## Motor Retainer Upgrade Notice

### CHEETAH Kit

Your kit now includes a new improved screw-on motor retainer. Please follow these instructions.

### REVISED LOCATION GUIDE

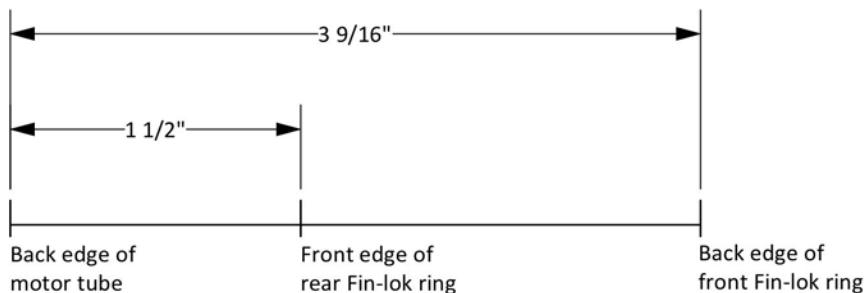
Use the LOCATION GUIDE above to make pencil marks along the motor tube line for location of the FIN-LOK rings per STEP 3. The new marks will move the motor tube rearward so that it is flush with the end of the body tube.

Follow Step 1 of FIN-LOK ASSEMBLY using new location marks as above.
